**GENOA CHARTER TOWNSHIP
BOARD OF TRUSTEES
REGULAR MEETING
OCTOBER 3, 2011
6:30 P.M.**

TO: Township Board
FROM: Kelly VanMarter, Planning Director
DATE: September 29, 2011
RE: 242 Community Church - Special Use Application, Environmental Impact & Site Plan Approval

Attention:	Kelly Van Marter, AICP Planning Director
Subject:	2142 Community Church – Special Use and Site Plan Review #2
Location:	7526 W. Grand River – south side of Grand River, between Hacker and Euler Roads
Zoning:	GCD General Commercial District
Applicant:	2142 Community Church 1661 N. Latson Howell, MI

**Re: 2/42 Community Church – Genoa Campus
Site Plan Review #2**

CONTRACTOR SHALL COORDINATE WITH ARCHITECT TO PROVIDE WYES IN STORM SEWER FOR DOWNSPOUT CONNECTIONS. (SEE DOWNSPOUT DETAIL ON SHEET C10.2)

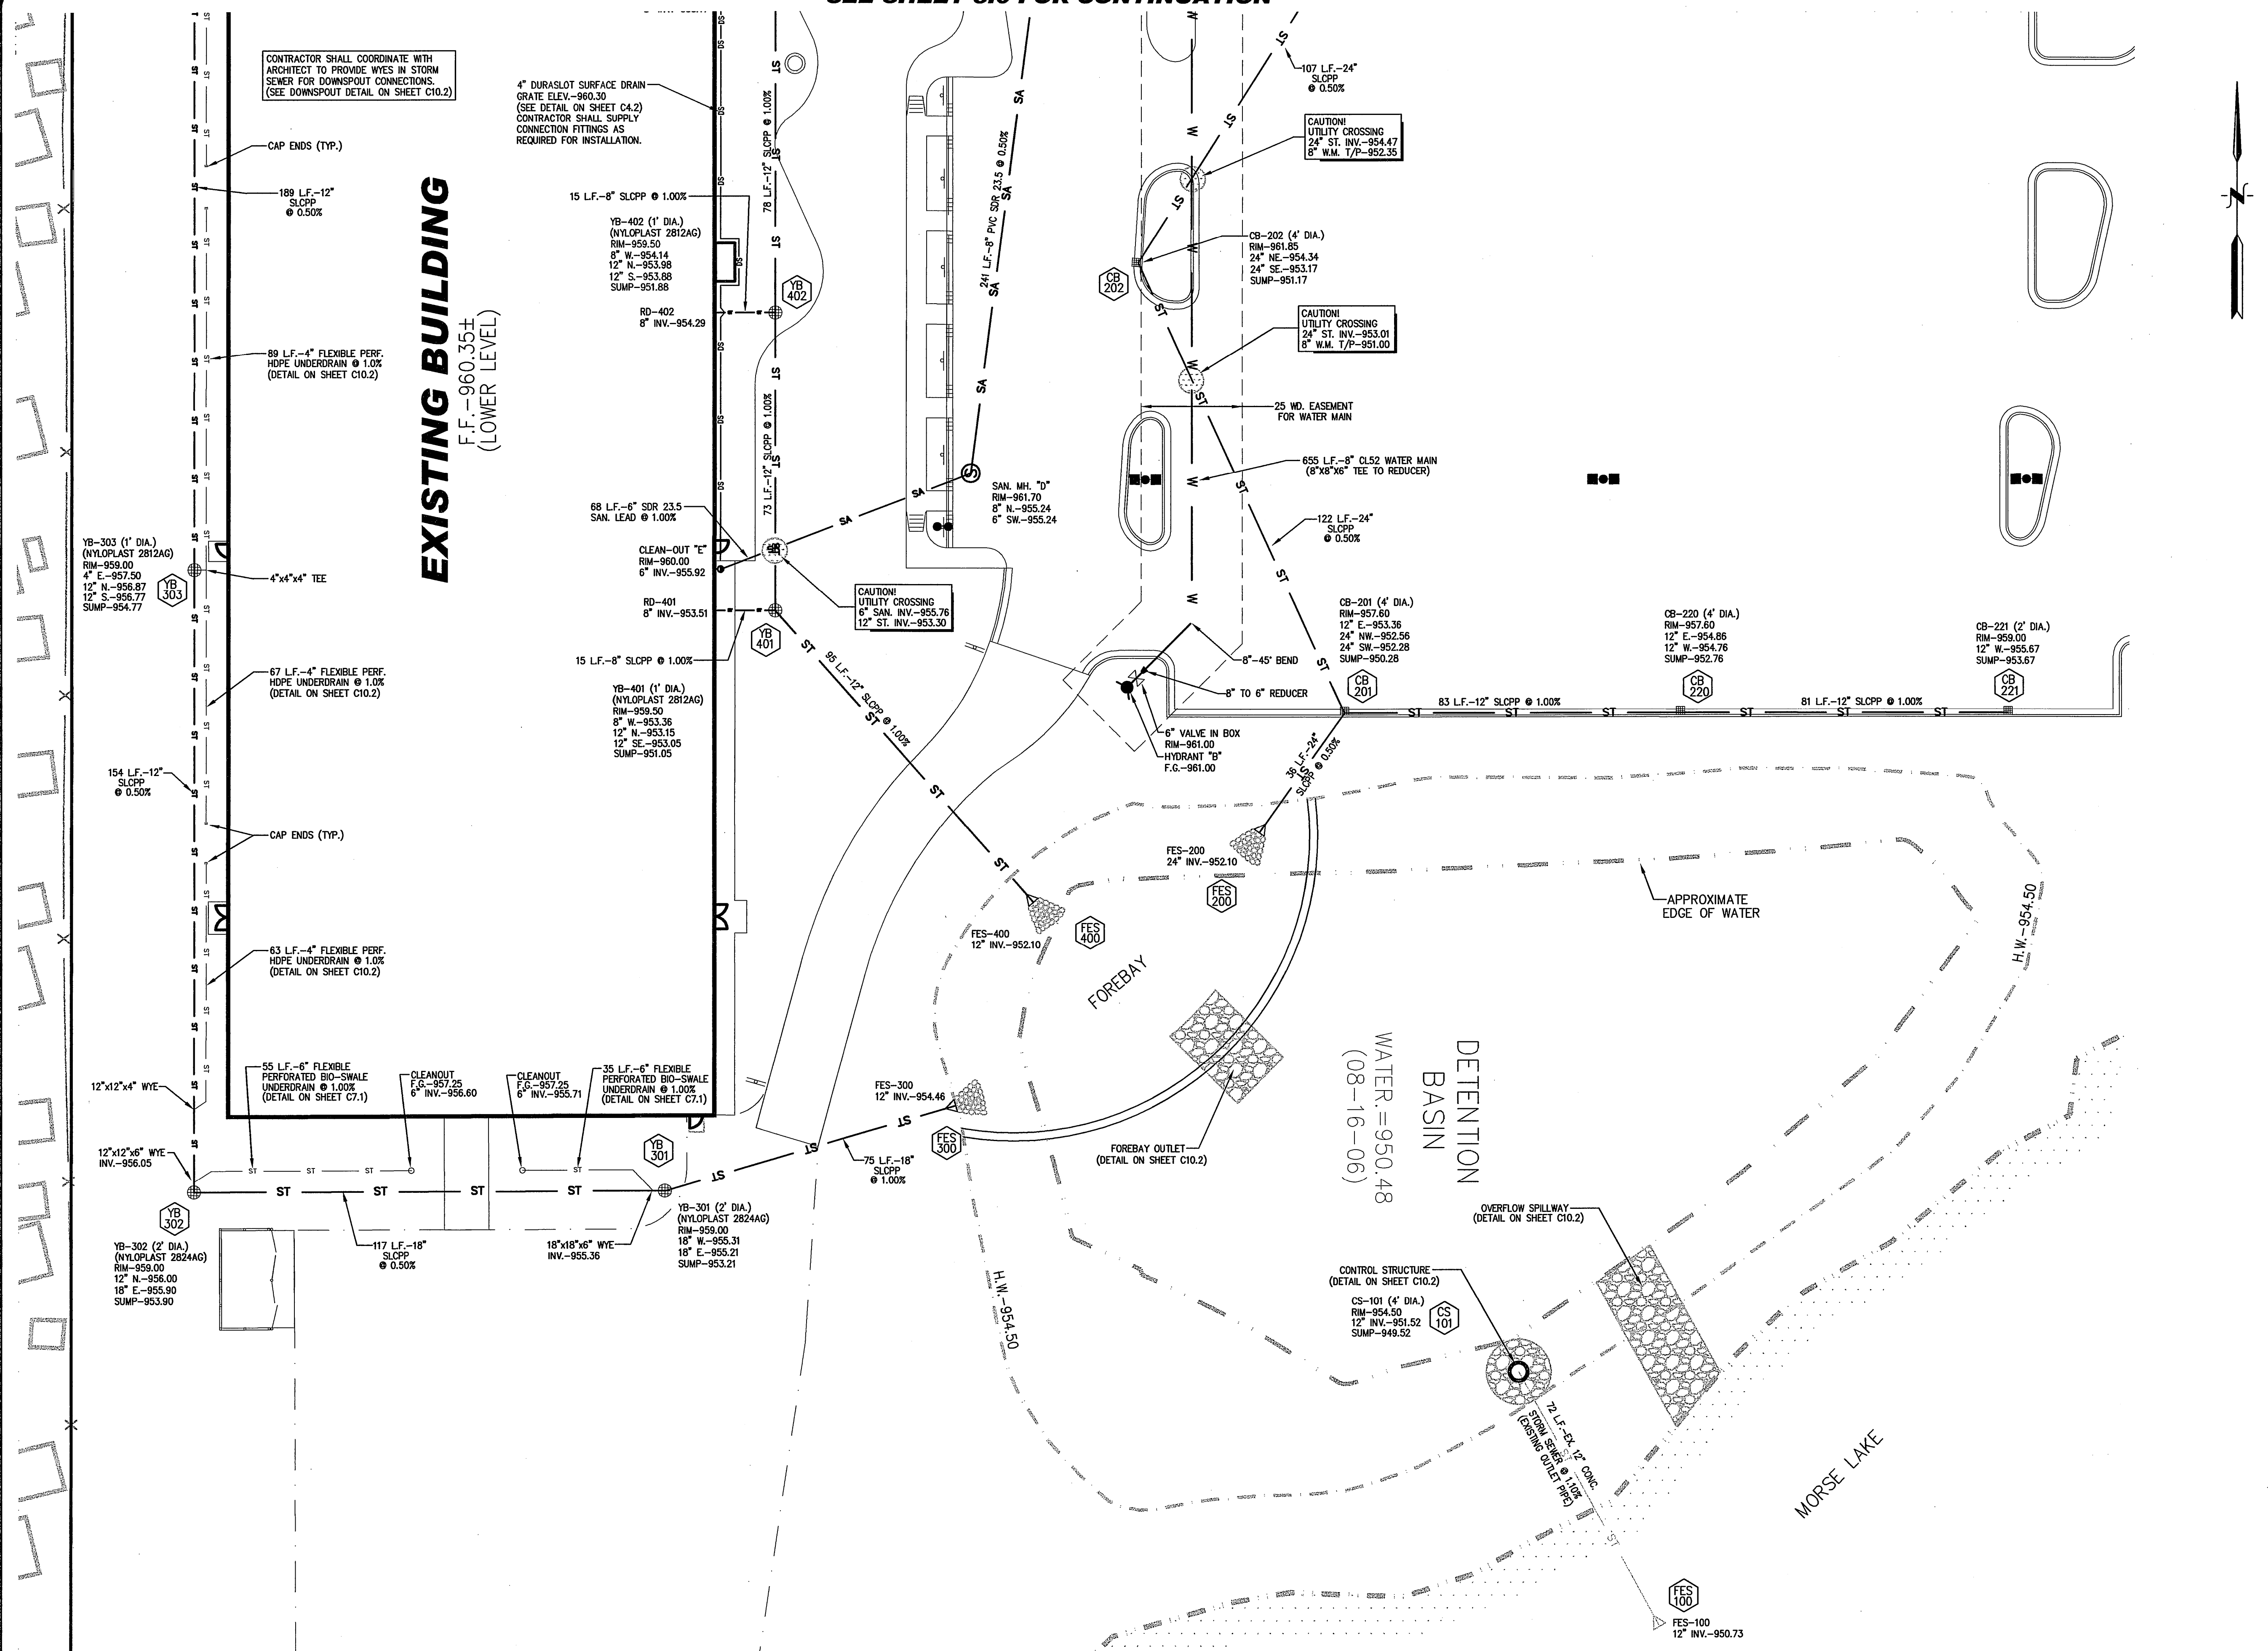
1. The proposed storm sewer around the building picks up the downspouts and roof drains. Due to the depth of the system and existing grades, the petitioner is proposing to use Nyloplast yard basins by ADS. Eight of the yard basins range from 6-inch diameter to 2-foot diameter with multiple pipes entering and exiting the basins. The petitioner needs to verify the size of the basins with the size and direction of the pipe to ensure that they are sized adequately.
